CERTIFICATE OF APPROPRIATENESS

Property: 1827 Arlington Street, Lot 6, Block 106, Houston Heights Subdivision. The property includes a historic 1,008 square foot, one-story wood frame single-family residence and a detached garage situated on a 6,600 square foot (50' x 132') interior lot.

Proposal: Alteration – Windows/Door

SOUTH SIDE ELEVATION

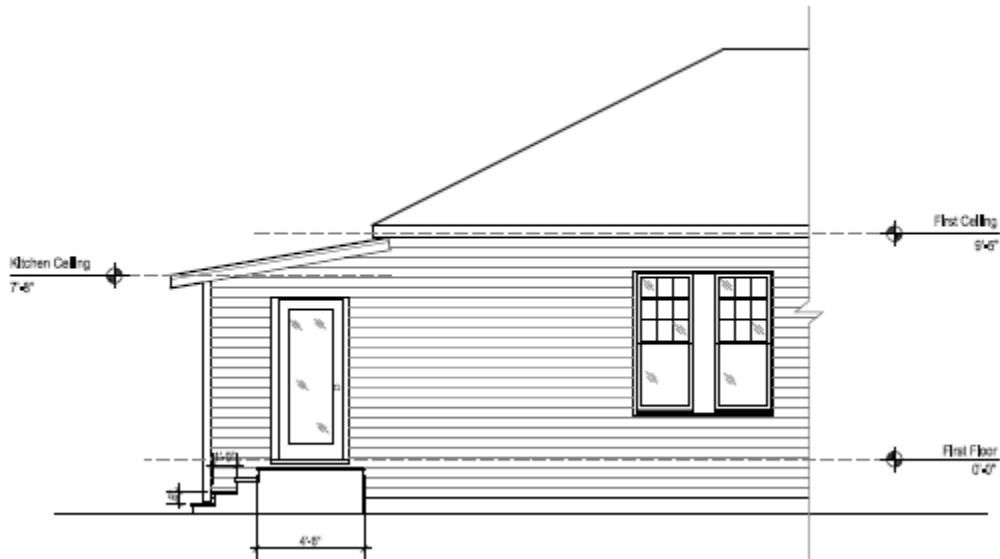
Windows/Doors: The existing residence features a combination of wood and aluminum windows. The applicant proposes to remove the aluminum windows from a prior addition and alter the existing window openings. All new windows to be installed will be 1/1 double hung wood windows. A new single lite solid wood door will also be installed. All proposed windows to be inset and recessed. See drawings and window/door schedule for more detail.

Exterior Materials: The existing residence is clad in vinyl siding. The applicant proposes to remove the vinyl to expose the wood siding underneath on the existing addition only. The wood siding will be repaired where necessary. A new set of wood steps will be constructed at the rear end of the south elevation.
